Links to Glen Innes Cycleways

Public Consultation Feedback Summary Report

Line Road

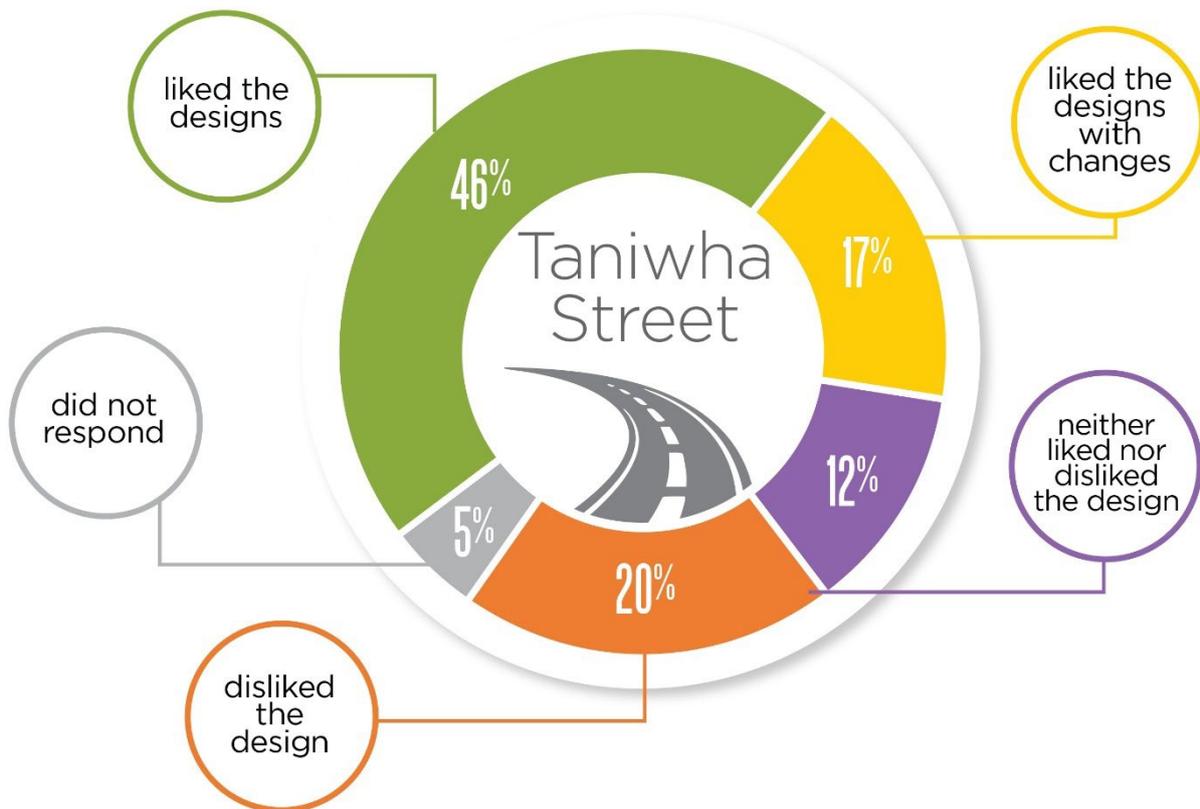
Responses that expressed concern for the Line Road cycleway design focused on safety, removal of car parks, removal of trees and the perception of the value of constructing the cycleway.

Seventeen people disagreed with the removal of car parking to allow for the cycleway. They indicated that a parking issue already existed and that this proposal and increasing housing in the area would only exacerbate it.

Thirteen people wanted to see improvements to planned crossings at the top of Line Road, where it meets West Tāmaki Drive, noting that this is a busy intersection and expressing concern about the lack of safety updates here.

Eleven people commented on the close proximity of bus stops to the cycleway and their concern for the safety of both cyclists and pedestrians as people crossed the cycleway to access bus services.

Thirteen people were concerned about driveways and how these would affect the smoothness of the cycleway surface and the comfort of cyclists using it. Concern was also raised as to whether cars may park illegally in their driveways, protruding into the cycleway because of the reduced car parking on the street. Two people specifically expressed concern for the visibility of cyclists to motorists entering and exiting driveways on Line Road, and the potentially fast speeds at which the cyclists could be travelling. A further ten people stated that Line Road is too busy for a cycleway to operate safely and that space on this road is insufficient for it to be safely installed.

Some people
commented on
the following
for
Line Road

-  Prefer the Line Road cycleway to be only one design (uni-directional or bi-directional)
-  Taking space from motorists to give to cyclists
-  The safety of crossing side streets

-  Ensure that the footpath and cycleway are clearly differentiated
-  Prefer the Line Road cycleway to be only bi-directional
-  Prefer the Line Road cycleway to be only uni-directional

-  Prefer cycleway to be entirely off road to reduce debris and risk to cyclists
-  The speed limit on Line Road being too fast for safe cycling
-  Concern for the possibility of “dooring”, where cyclists collide with parked cars as doors are opened

-  Wanting the whole cycleway to be off road
-  Safety crossing to link from the uni-directional section to the bi-directional and vice versa
-  Objection to raised pedestrian crossings

-  The safety of navigating this road for disabled and elderly people
-  Prefer the Line Road cycleway to be only bi-directional

Taniwha Street

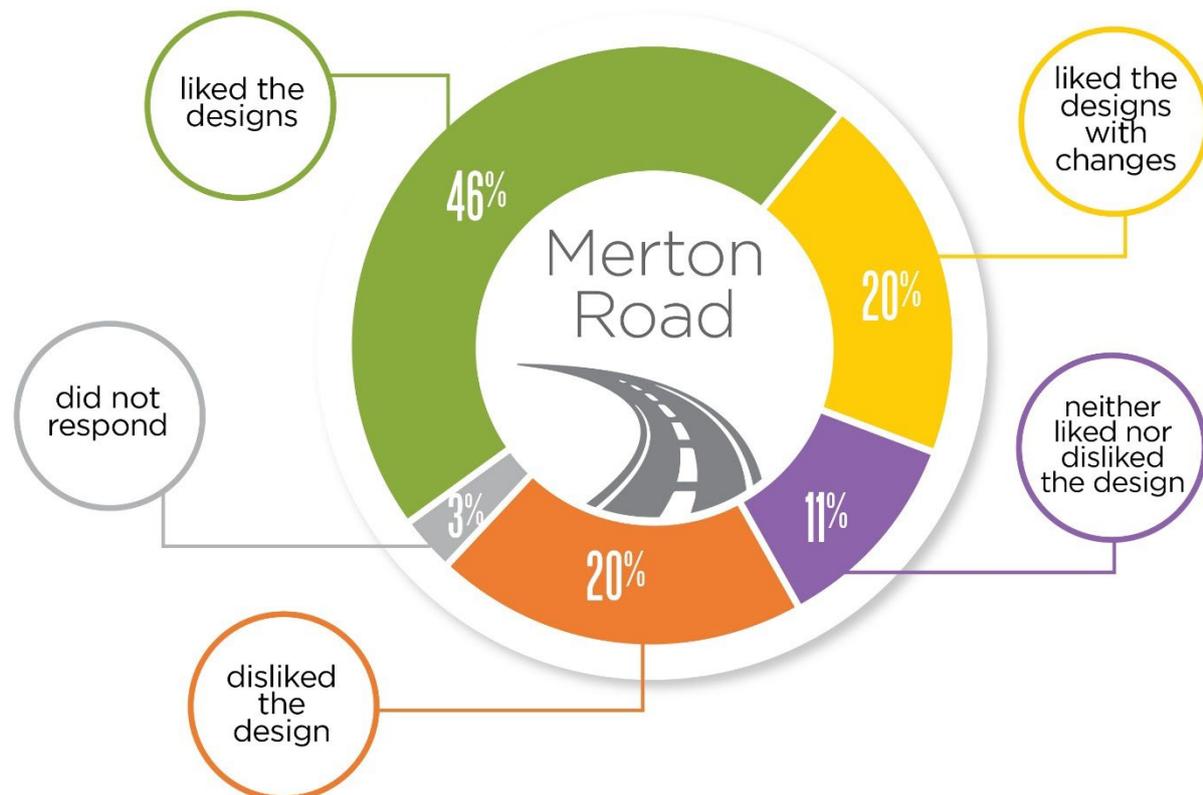
Conversely, 16 people were concerned about the removal of 11 parking spaces at the Line Road end of Taniwha Street. They were worried about the impact that this could have on businesses if customers struggled to get parking and on the usage of trains as public transport if people were not able to park their cars.

The most common concern for Taniwha Street was pedestrian space and safety. Many comments (20 people) stated that the footpaths, particularly close to the town centre, are too narrow for pedestrians to move around safely and need to be widened. People said that they are concerned for the safety of pedestrians when the cycleway is in use, and they wanted to see clear delineations between walking and cycling spaces in the form of painted paths to help avoid accidents between pedestrians and cyclists.

Eight people questioned the number of pedestrian crossings to be installed in Taniwha Street as they were concerned about the effects of these on traffic flow through the street and therefore traffic congestion.

“Please can you widen the footpaths here, it’s just too narrow through the shops. You can’t expect people to safely share this space if there’s not enough space to share.”

“Too many zebra crossings and traffic lights will cause unnecessary expense and congestion. Not broken, so don’t fix it.”

Some people commented on the following for Taniwha Street

-  Prefer a bi-directional cycleway on one side of the road only
-  Driveways – safe to cross for cyclists and a smooth surface to ride
-  Taking road space away from motorists
-  The risk of “dooring” - cyclists colliding with parked cars as doors are opened
-  Unhappy with the removal of trees
-  Want a reduced speed limit on the road to cater for cyclist safety
-  Disruption/traffic management during construction
-  The length of time taken to get to this consultation
-  Removal of pedestrian crossing outside train station
-  Objection to raised pedestrian crossings
-  Clear differentiation for users between footpath and cycleway
-  Additional pedestrian crossing between Maybury Reserve and Point England Park

Cycleway layout	Can the cycleway be bi-directional on just one side of the road to reduce the space and the disruption to central Glen Innes?	The proposed design, with a uni-directional cycleway on each side of Taniwha Street, will significantly improve the connections to the town centre for cyclists coming from Apirana Avenue north and south. The final cycleway design will seek to minimise the disruption to the town centre where possible.
	Road designation	Can the roads surrounding Glen Innes Train Station be car free roads?	<p>This is an option that could be considered in future plans.</p> <p>As part of Links to Glen Innes Cycleways, speed calming measures will be introduced in the Glen Innes town centre. This will improve the safety for active travel modes as well as other travel modes on the network.</p>
Construction	Disruption	Query around what will be done to support businesses and minimise disruption during the construction of the cycleways, particularly on Taniwha Street.	<p>During the preparation phase for the construction, the project team engaged with the business community and Glen Innes Business Association to understand the essential requirements during construction. AT will then work with the contractor to come up with a suitable traffic management plan.</p> <p>All construction dates and plans will be communicated with all affected stakeholders prior to the commencement of construction.</p>

Morrin Road

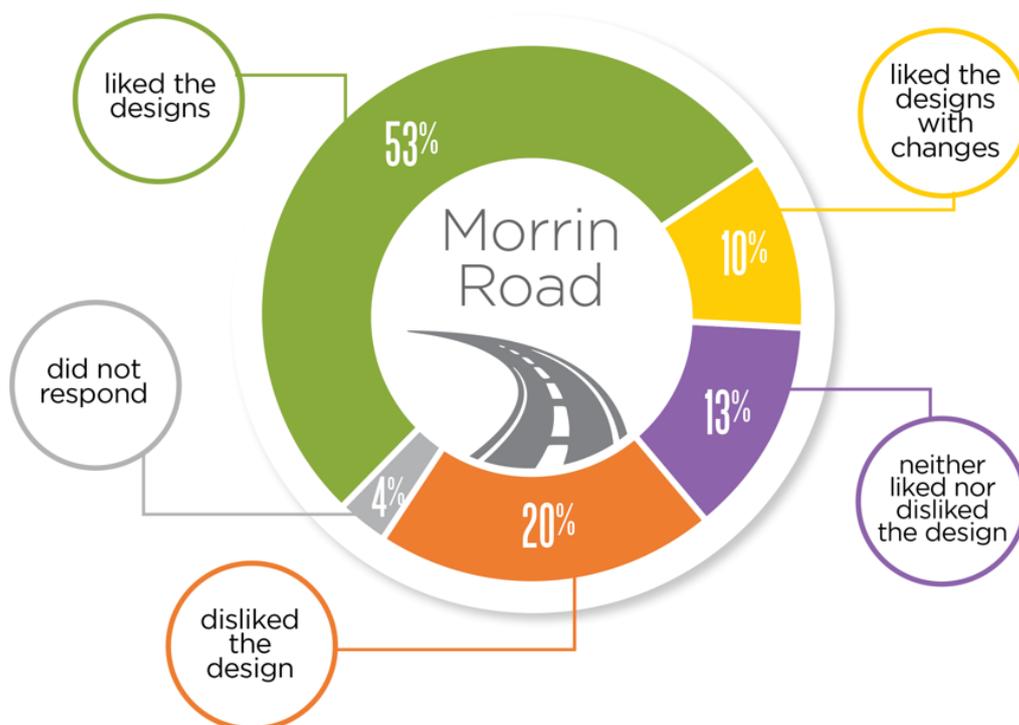
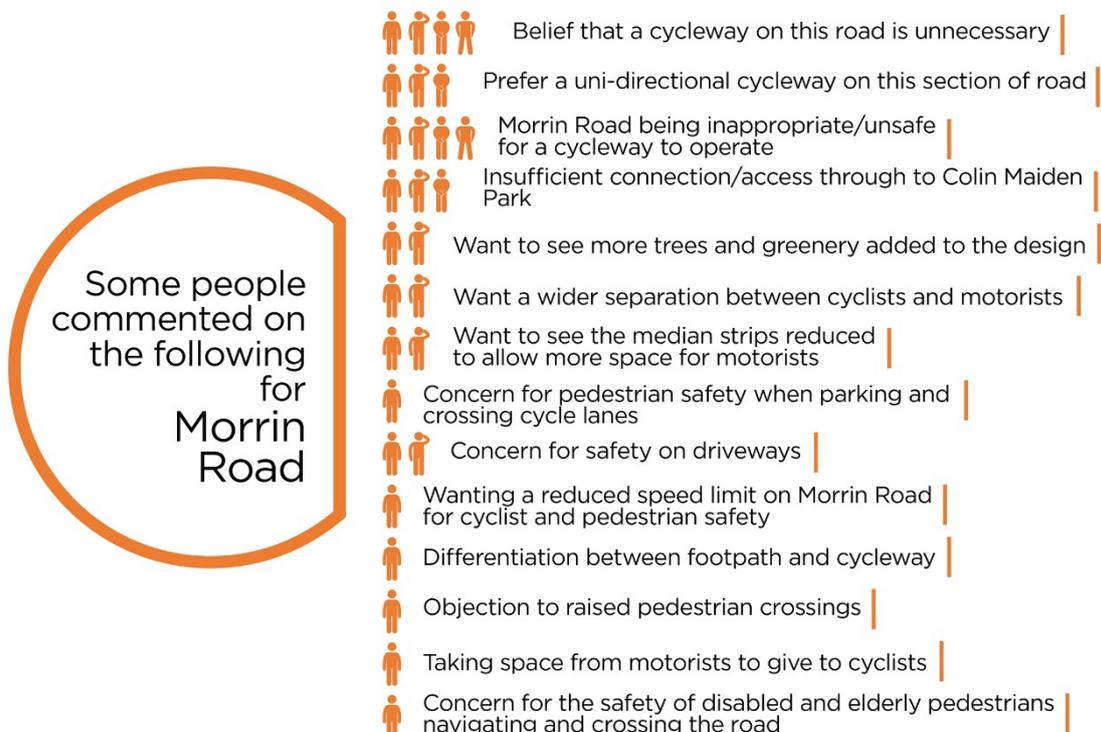
The most common issue raised in the comments for Morrin Road was the proposed removal of parking (14 comments). The design includes the removal of 85 car park spaces from this road. Morrin Road borders Colin Maiden Park and the housing developments at the former University of Auckland site.

People stated that this street is very busy on weekends, with cars parking for sports. Several people noted that this street is used by train commuters for car parking during the week. They stated that parking in Colin Maiden Park is insufficient for sports attendees and that the removal of car parking

spaces would be detrimental to the use of these grounds and put children and families at unnecessary risk as they navigated to the park.

“Where do the people from the 85 parking spaces park when they want to participate in sports or work – they are not all local or can easily get public transport to the area of, indeed, do not all have or want to have a bike to use a cycleway.”

“This road is wide enough to have parking on both sides with the design. I also cannot understand why so many car parks have been taken away when it is right next to public playing fields and the netball centre, which has a tiny carpark. These streets are packed with cars parked on Morrin Road when sports games are on at the park and netball centre.”

Roundabout safety was an issue that arose in seven comments. These stated that the roundabouts that connect Morrin Road are very dangerous and busy for cyclists to navigate. People were concerned that the proposed design would not improve this safety risk for cyclists sufficiently. People commented that, as drivers focused on entering the roundabout and avoiding other motorists, the visibility of cyclists to motorists would likely remain poor and that fast car speeds through those roundabouts would continue to contribute to the risk to cyclists.

The number of pedestrian crossings the design proposes to add to Morrin Road was considered excessive, with people concerned for pedestrian safety and traffic flow. Four people commented that they would prefer to see the “large berms” and footpath taken for use as cycleways rather than road space.

“An option to replace lost car parks on Morrin Rd for train commuters should be provided, possibly within the Netball court or old University areas. Many people park on Morrin Rd and walk to the GI train station.”

Morrin Road			
Design Suggestion	Shared path	Remove the section of shared path	Providing a dedicated cycleway is the main deliverable of this project. On Stonefields Avenue and Morrin Road, cyclists will be separated from pedestrians, with limited shared path proposed at corners of the roundabout due to spatial constraint and other project constraints.
	Planting	Suggestion to remove the median strips from this section of road, and reallocate the space to form a planted strip between the cycleway and the road.	This suggestion has been noted as the design input. The flush median is providing a safe place for the right-turning traffic to stay and find the gap between traffic. AT will investigate the viability of planting between the cycleway and road considering project

constraints including safety, maintainability, spatial, and budget availability.
	Roundabout	There appears to be a lot of space at the roundabout at Morrin Road / Stonefields Ave / Allison Ferguson Drive, so consideration should be given to a proper Dutch Roundabout consistent with the thinking above at the other end of the street. In particular, there is ample opportunity here for fully separated cycling and walking facilities and there is no need for the sorts of compromises in terms of sharp bends, poor sight-lines and shared spaces shown in the consultation plans.	The construction of a Dutch Roundabout is not proposed at the Morrin Road / Stonefields Ave / Allison Ferguson Drive. This option could however be considered in the future, should additional funding become available.
	Planting	The planting at the roundabouts connected to Morrin Road reduces visibility and should be removed to improve cyclist and pedestrian safety when crossing at these roundabouts.	A sightline check will be undertaken to ensure that sightlines requirements are met. This will ensure no blocked sight from the vehicle's perspective to make them remain aware of the surrounding hazards. Measures (e.g., trimming, plant removal) will be considered if blocked sightlines exist due to vegetation.

Stonefields Avenue

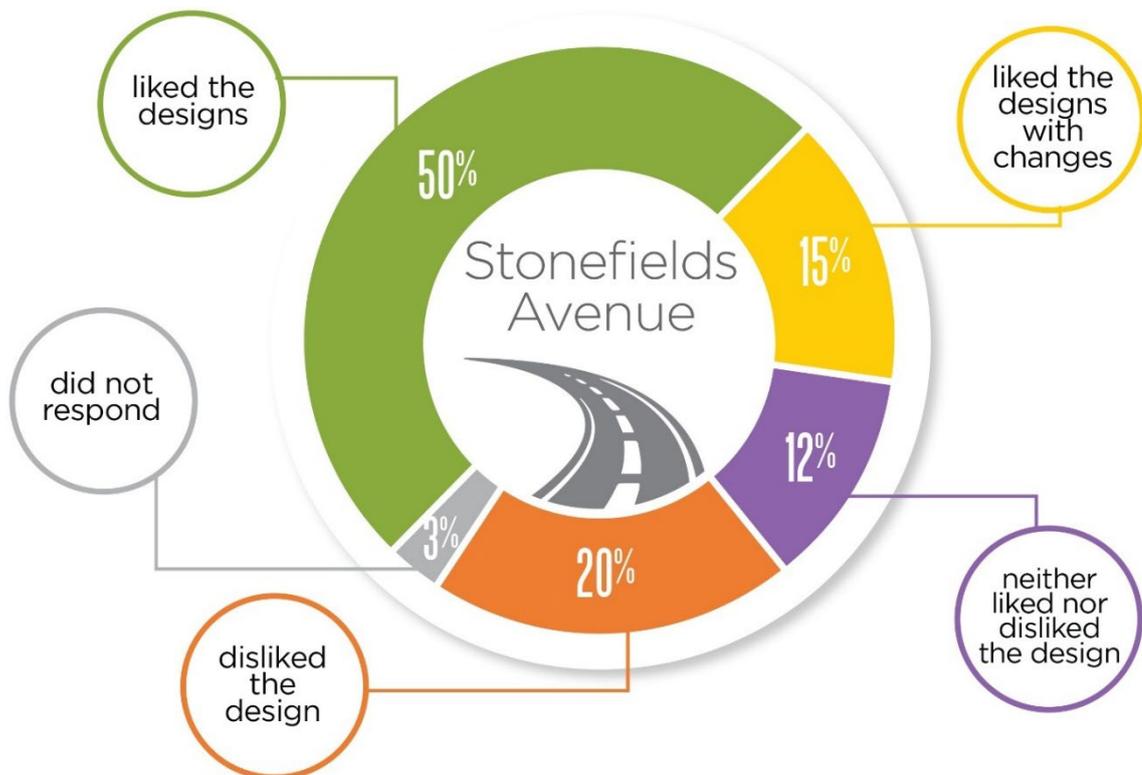
The most common concern (16 responses) related to the section of the cycleway approaching the traffic light-controlled intersection of College Road and Stonefields Avenue. People were disappointed to see the bike path “stop short” before the lights – they wanted to see the design amended to continue to the intersection. They wanted to see a smoother connection from Stonefields Avenue to College Road, and one respondent wanted curb ramps for safety.

“Looks great, but would be good if the cycle lane went all the way from the lights (i.e., from roundabout to lights on both sides of the road).”

“Please connect all the way to the traffic signals at the south end, rather than just stopping short.”

The lack of parking in this area was undesirable to 16 people, who stated that Stonefields Avenue is heavily utilised by train users and sports attendees, particularly for weekend netball, as well as for the markets that pop up on Sundays. The safety of the Morrin Road/Stonefields Avenue roundabout was commented on by 15 people. They stated that the paths around the roundabout in the proposed design are too narrow and unsafe for cyclists and pedestrians.

“Please make the roundabout a proper one – the shared paths and narrow sections really undermine the work you’re doing here.”

“Bike paths at roundabout too narrow, remove shared path sections if possible – much prefer separated bike lanes.”

“I think parts of the bike paths at the roundabout connecting Morrin Road and Stonefields Road are too narrow/are shared paths.”

-  Prefer a bi-directional path on this section to connect seamlessly with Morrin Road
-  Don't want space taken from motorists
-  Opposing raised pedestrian crossings
-  Concern for disabled and elderly pedestrians (including confusion with tactiles used at crossings)
-  Want space to be taken from footpath not road
-  Want car park at roundabout changed to be left turn only in and out for safety
-  Desire for reduced speed limit
-  Want to see more trees in the finished plan
-  Want better pedestrian access for travel to train station

Cycleway layout	Heading south turning from College Road down Stonefields Avenue, start the cycle way at the very beginning of the road rather than after the two car lanes have merged into one.	<p>AT are currently reiterating the cycleway layout to achieve better outcomes possible following feedback from public and residence association. This will also affect the layout of the cycleway around the southern side in which the comment talks about. We will provide an update when the design is finalised.</p>
	Roundabout	Widen the pedestrian and cycleway around the Stonefields Avenue/Morrin Road roundabout, to make it easier to navigate.	<p>The proposed design is required to follow the AT Transport Design Manual (TDM) which outlines guidelines and design standards, including the minimum width for footpath and cycle path to maintain a safe environment for all users. We will work with the designer team to shape the detailed design, ensuring the proposed</p>

Intersection	Can the junction with College Road be improved to offer priority to non-motorised users? Suggestion to better align the College Road intersection with Vision Zero principles, providing clear space for cycling, walking and motorised traffic.	AT are currently reiterating the cycleway layout to achieve better outcomes following feedback from public and residence association. This will also affect the layout of the cycleway and footpath within the junction the comment talks about. An update will be provided when the design is finalised.
	Intersection	Can the junction with College Road be improved to offer priority to non-motorised users?	AT are currently reiterating the cycleway layout to achieve better outcomes possible following feedback from public and residence association. This will also affect the layout of the cycleway and footpath within the junction the comment talks about. An update will be provided when the design is finalised.
